Access Compliance Report

Public Rights-of-Way

(Curb Ramps)

Intersection ID: 10032491	Main Street: N_BREVARD_ST	Cross Street: N/A	Location:	N
ADA ID: 04A638C6D31D	Ramp Type: BlendTrans1	Initial Pass/Fail: Pass	Overall Compliance: No	Severity Score: 10
Codes/Mitigation Info/Possible Solution		Field Measurements/Component Compliance

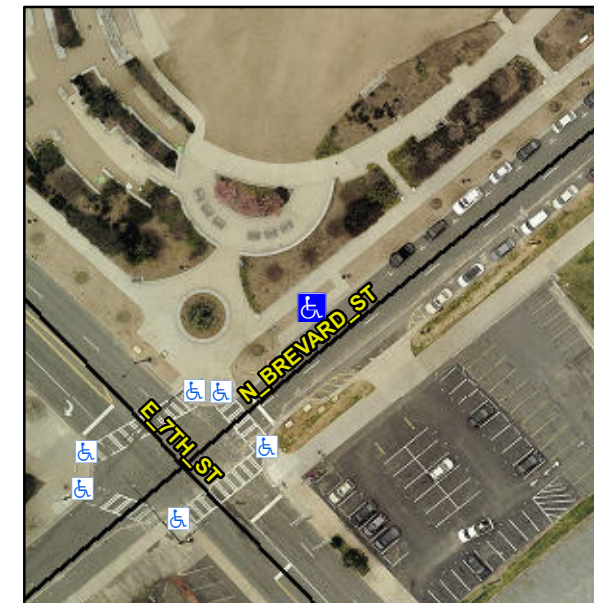
ACCESS AISLE RAMP

R304.5.3, R305, R304.5.4

Remove & Replace Curb Ramp With Two New Directional Ramps or Equivalent. Remove & Replace Gutter.
